Product Change Notice

Issue Date: 19-January-2021

New dice replacement for seven segment display

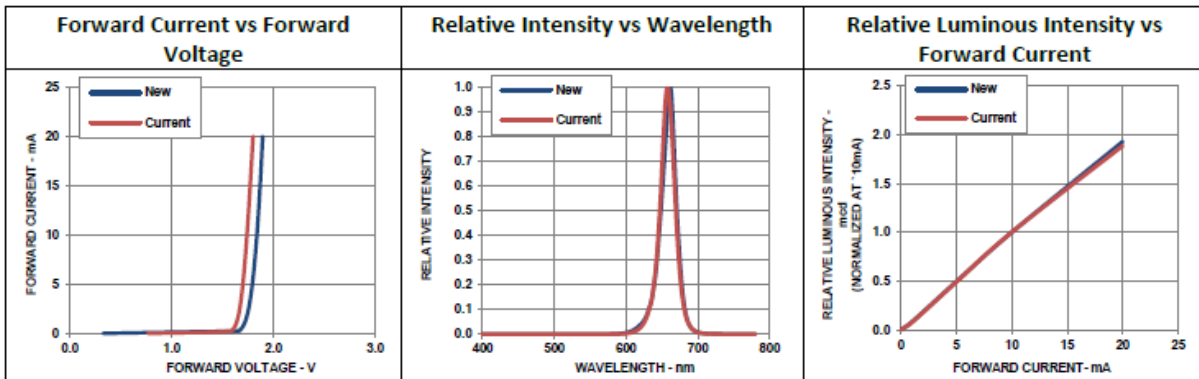
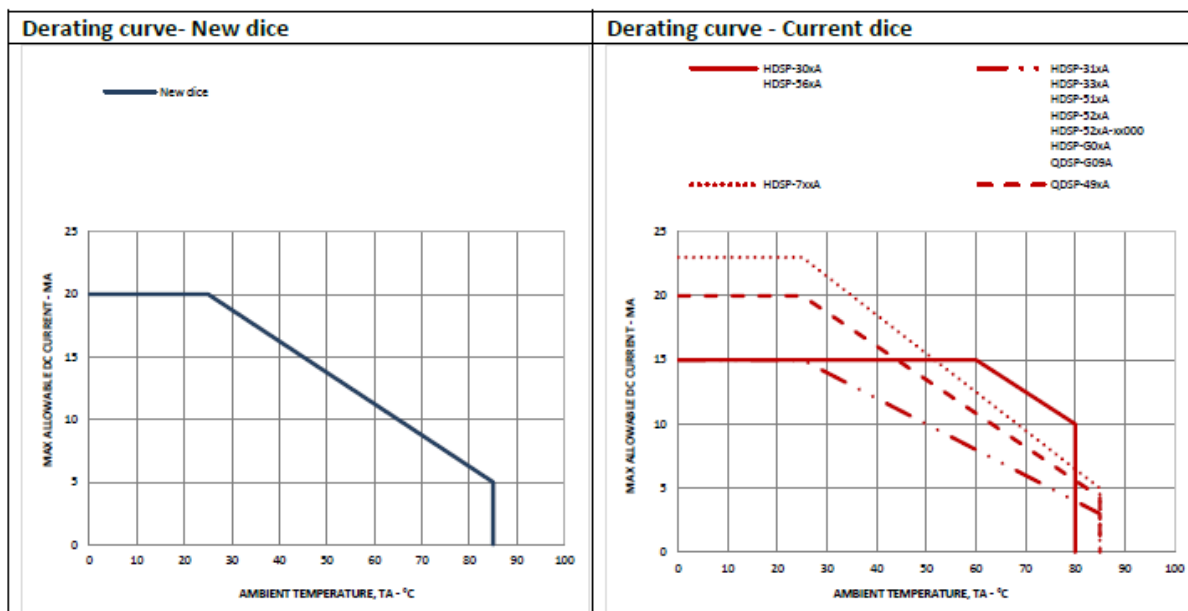
The new dice (AlInGaP) shall be replacing current dice (AlGaAs) for part number above.

Obsolescence of current dice by dice supplier.

There is no change in fit and form of the product as per datasheet.

The storage temperature& operating temperature range will be standardized to -40°C/85°C.

Below are the comparison of the Electrical / Optical characteristic between the current & new dice:
